Final Bridge Type Study

Freedom Trail Phase IV
Akron, Ohio

Bridge over Broadway Avenue
Ramp Bridges to University Avenue

**RE: Final Bridge Type Study
Freedom Trail Phase IV, Akron, Ohio**

REVISIONS	MARK	DATE	DESCRIPTION
SUMMIT METRO PARKS			
FREEDOM TRAIL PHASE IV BRIDGE NO. 2 PLAN AND PROFILE			
SUMMIT METRO PARKS, CITY OF AKRON, SUMMIT COUNTY, OHIO			
DATE	11/29/16		
SCALE	None		
JOB NO.	60-08322-00		
SHEET	1/4

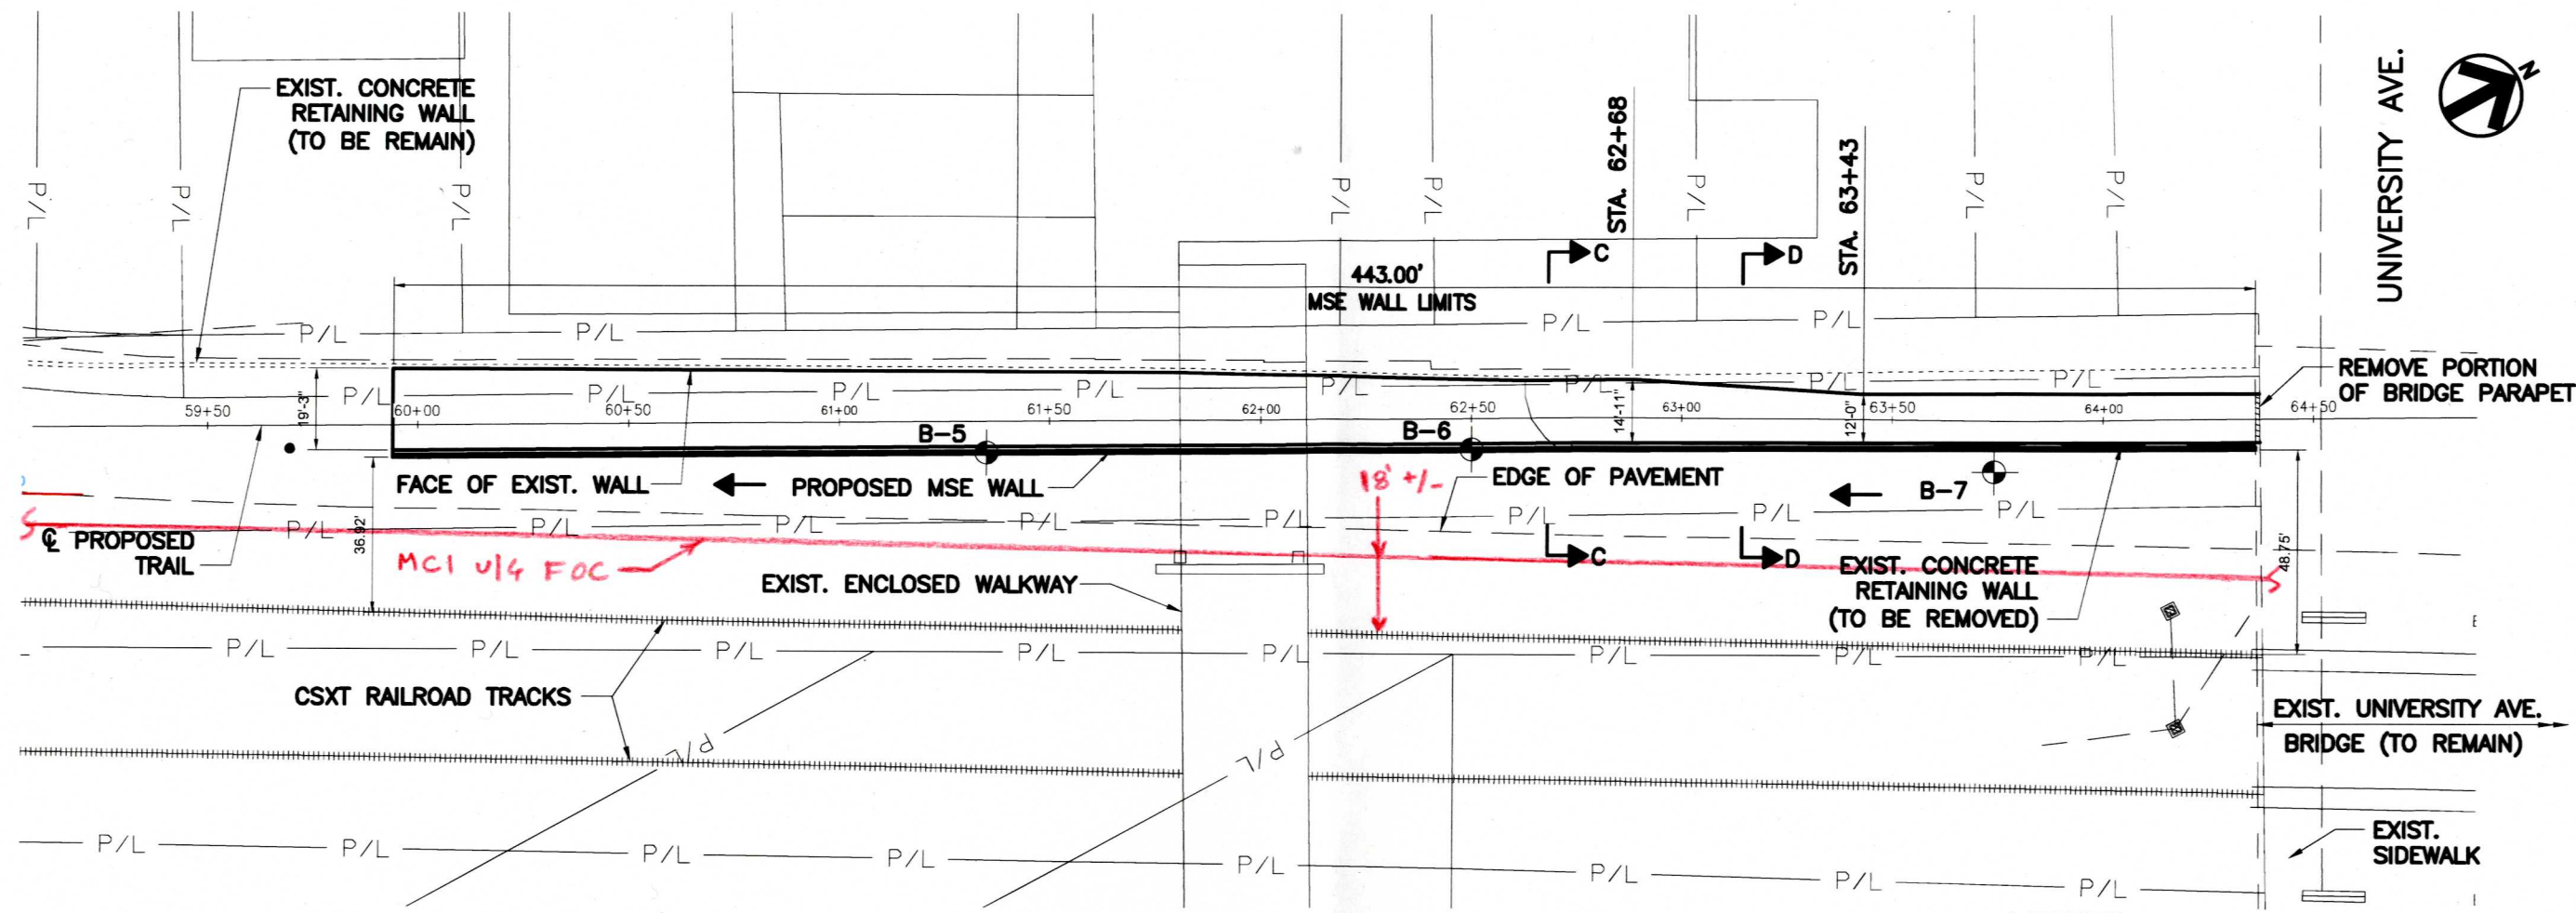
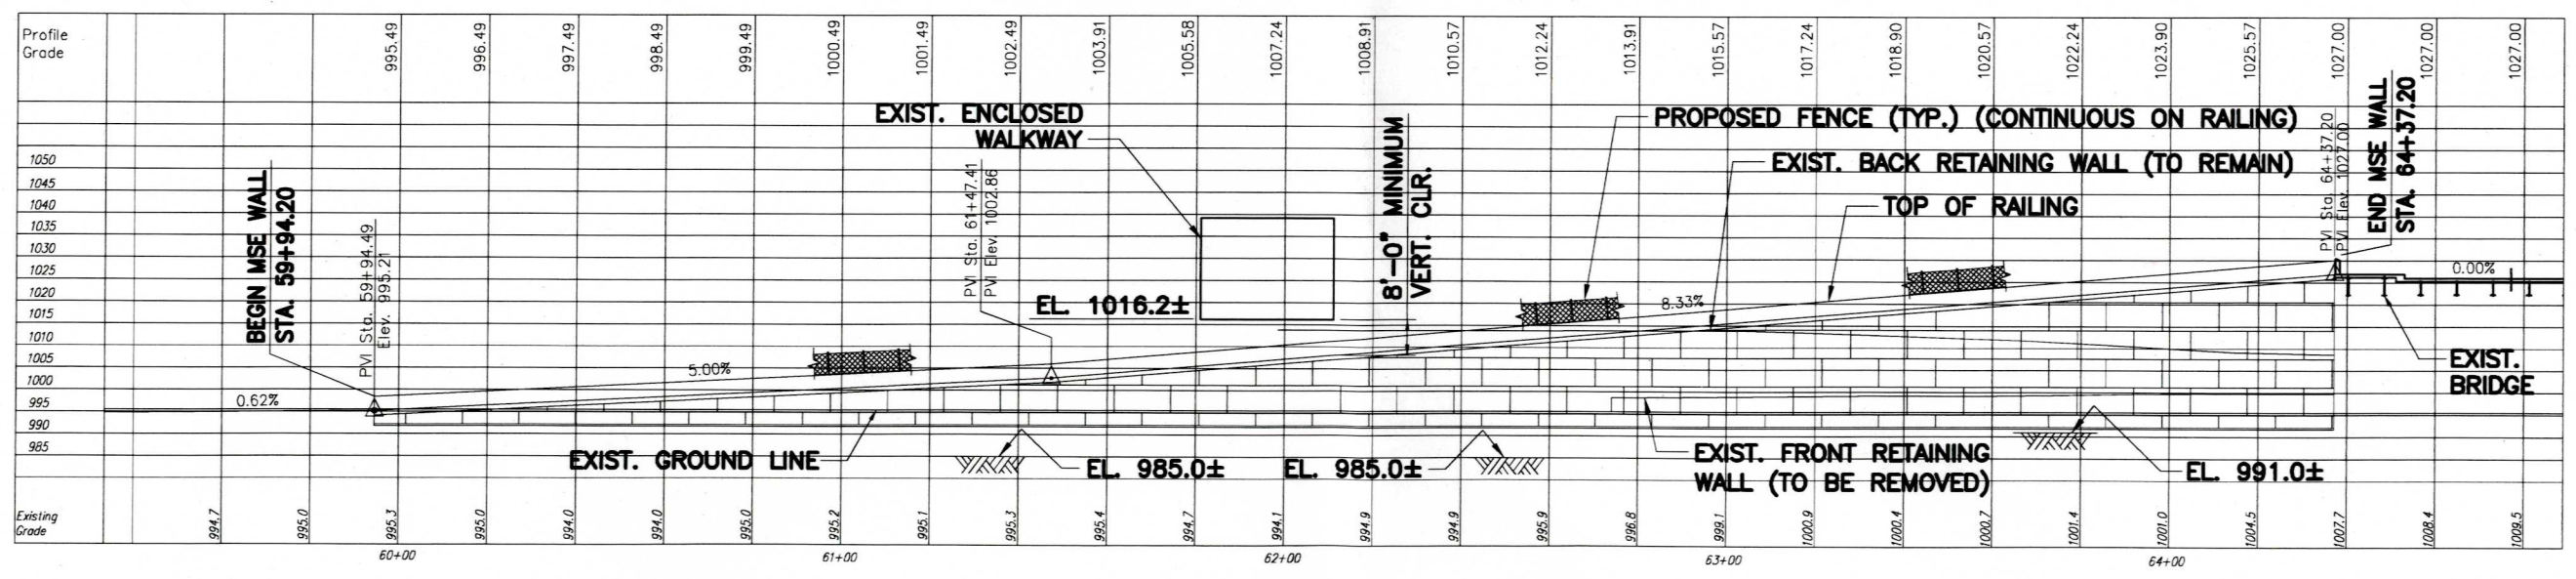
1. Sheet 1 of 4, Plan and Profile - south of University Ave.: Existing sewers are not shown. Existing manholes may have to be adjusted to proposed finish grades. Please review and show existing sewers.
2. Sheet 4 of 4, Plan and Profile - south of University Ave.: Where is this Typical Bridge Section located? South of University Ave. does not appear to have bridge sections. Bridge sections to the north of University Ave. indicate using Typical Section E-E, Sheet 2 of 3. Please clarify.
